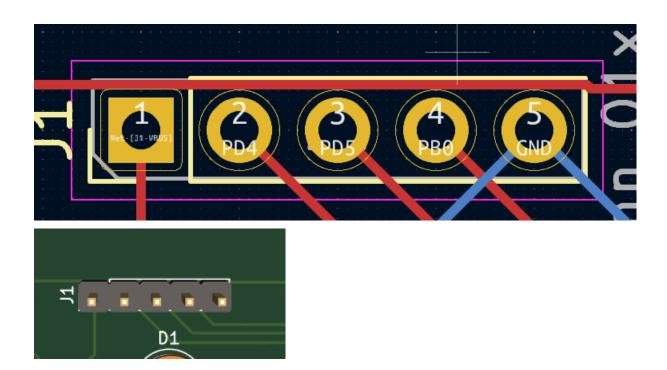
Wrong symbol in schematic for breakout board. Consider using the correct symbol in order to ensure correct wiring.

USB connection should be differential and length matched, if using a USB/UART bridge it must be included in your schematic. If you are doing USB directly with the tm4c, declare to kicad using the correct naming scheme that these are differential pins, so that KiCad can help you route them. Its nice that you are using pins that are both UART+USB so you can fall back on either if any fails.

USB connection may be flipped, the one we are giving has the following pinout

```
PORT |

| GND IO D+ D- VBUS |

Your regulator is only 100mA ensure that you have enough headroom for all components used. Screen + CPU is already about 60mA, all LEDs, Buttons, and IMU should total to less than 40mA

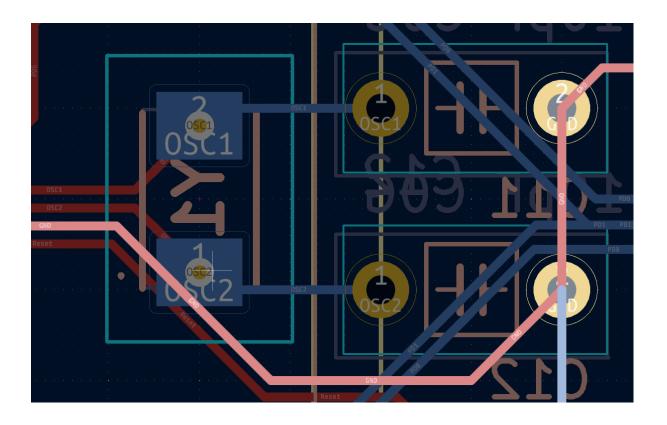
GND track for the clock should be a dead end, Consider connecting the button and header to a different part of the gnd net.

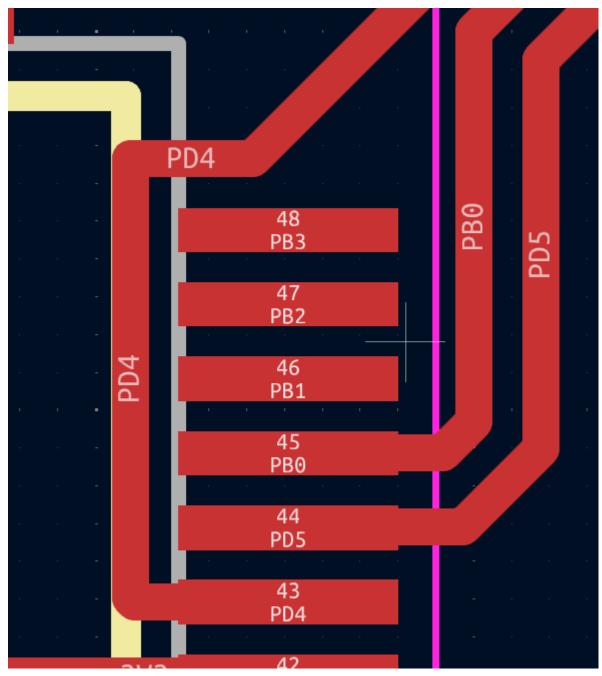
Don't use minimal spacing for traces when possible. (ALSO PD4 and PD5 must be length matched)

Please fix this, especially as it is USB.
